UNITARY PLAN UPDATE REQUEST MEMORANDUM

SUBJECT Consent Order for Environment Court appeals relating to the Auckland Unitary Plan Operative in part (15 November 2016)

CONSENT ORDER

ANNEXURE B

Redhills Precinct : Precinct plan 1 - Consent Order Version
20 March 2019

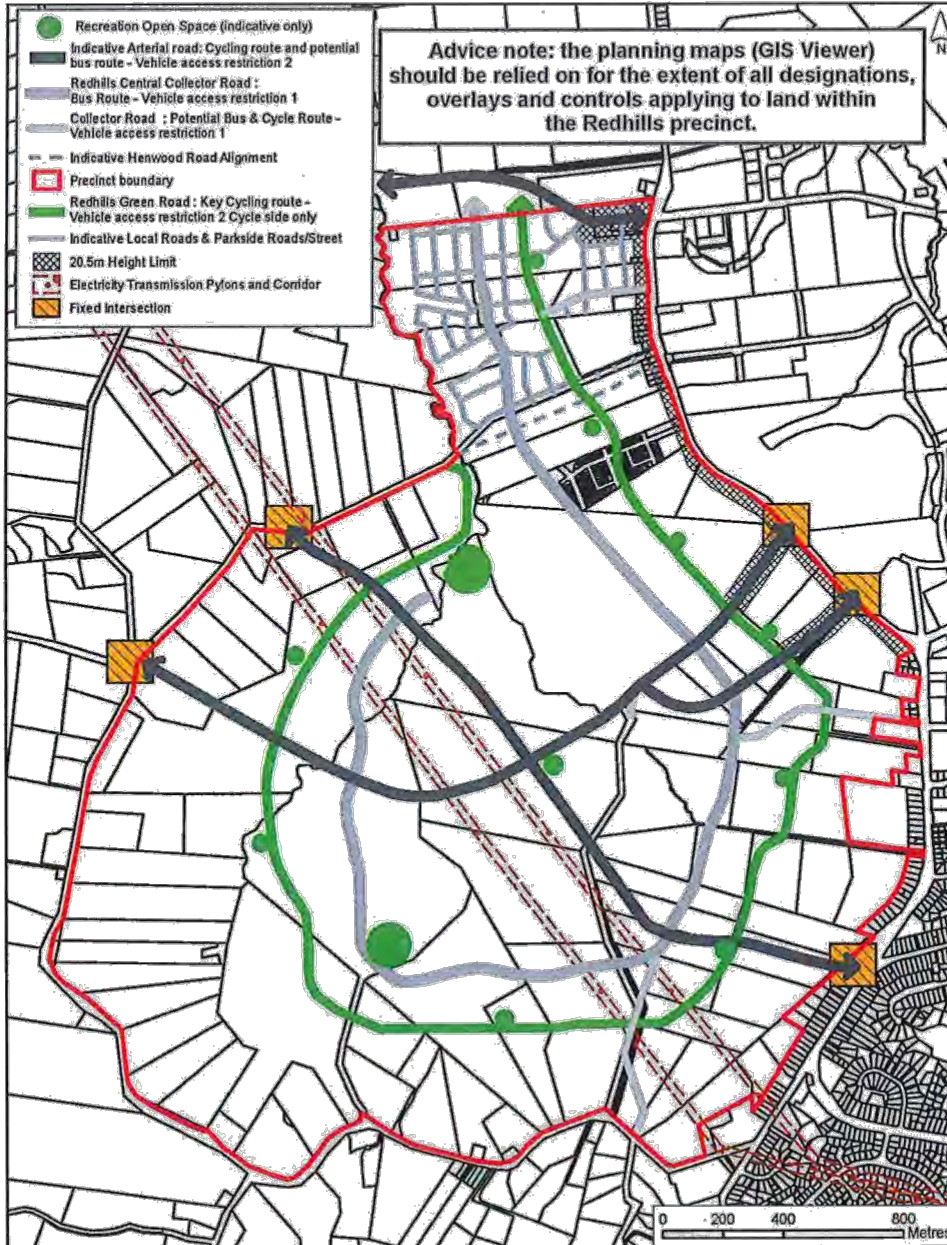
- (a) The Precinct Plan is proposed to be amended so as to:
- (i) Show five 'fixed' intersections. The north-south arterial is shown to run from Henwood Road in the north to Royal Road in the south. The eastwest alignment is shown to run from Nelson Road in the west, and splitting into two roads to the east of the Precinct to connect to both Baker Lane and Dunlop Road.

- (ii) Make minor changes to the extent of the collector roads so as to align with the northern extent of the realigned north-south arterials. Delete the local road network from the precinct plan where it applies to the Universal Home's site.

- (iii) Show a 20.5 metre height limit along the Dunlop and Baker Lane arterial roads from Fred Taylor Drive to the Green Road. This height limit was realigned from the original east-west arterial alignment shown as joining the Fred Taylor Drive/Don Buck Road roundabout intersection.

- (ii) Confirm the Redhills Precinct's fixed intersections where the arterials connect with the surrounding roading network;
- (iii) Confirm that, other than these fixed intersections, the location of the arterials in the Precinct Plan is indicative only;

- (a) The appeals are allowed to the extent that the Precinct Provisions are amended in accordance with **Annexure A**, and the Precinct Plan is replaced with that in **Annexure B**.
- (b) The appeals are otherwise dismissed.
- (c) There is no order as to costs.

Replace Precinct Plan with the following:

I610.10.1. Redhills Precinct: Precinct Plan 1

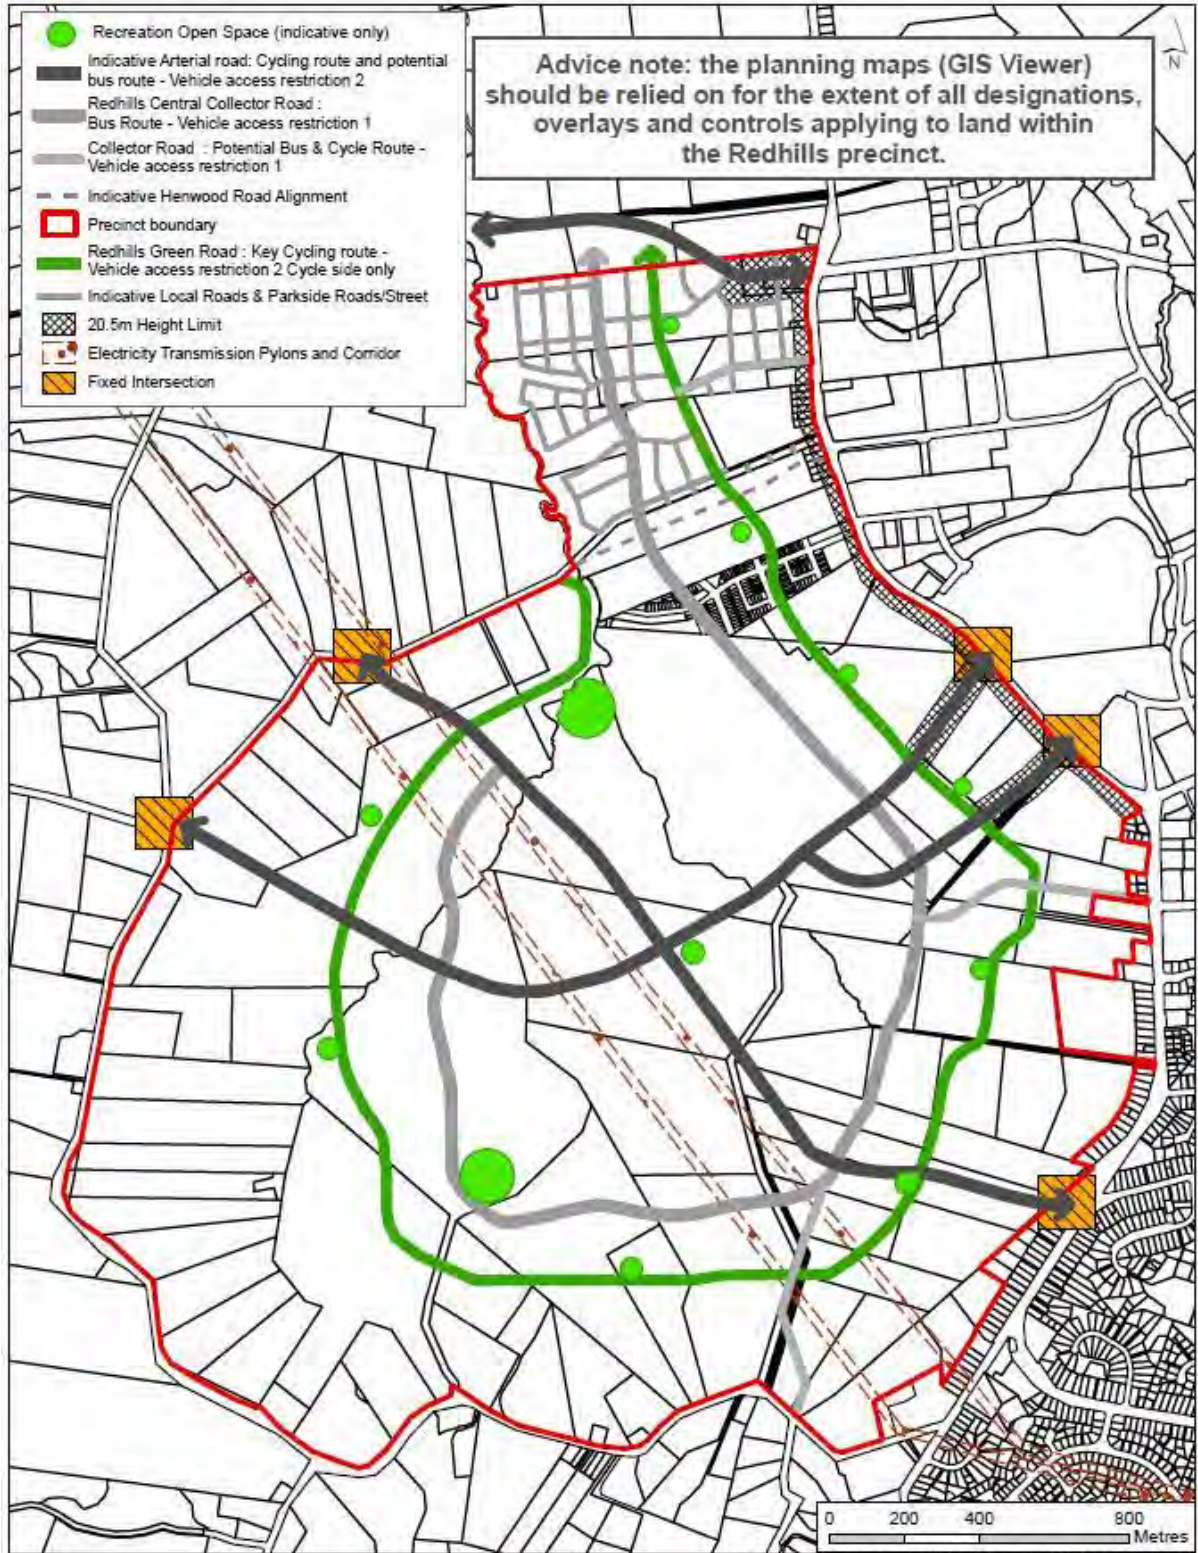
The indicative arterial road alignments have fixed points where they meet the existing surrounding road network identified in Redhills Precinct: Precinct Plan 1. For the north-south arterial road, these fixed points are the intersections with Henwood Road at the symbol () on the Redhills Precinct Plan 1 in the north and Royal Road in the south.

Subject to the fixed and confirmed intersection points identified above, the arterial roads are marked "indicative" in Redhills Precinct: Precinct Plan 1.
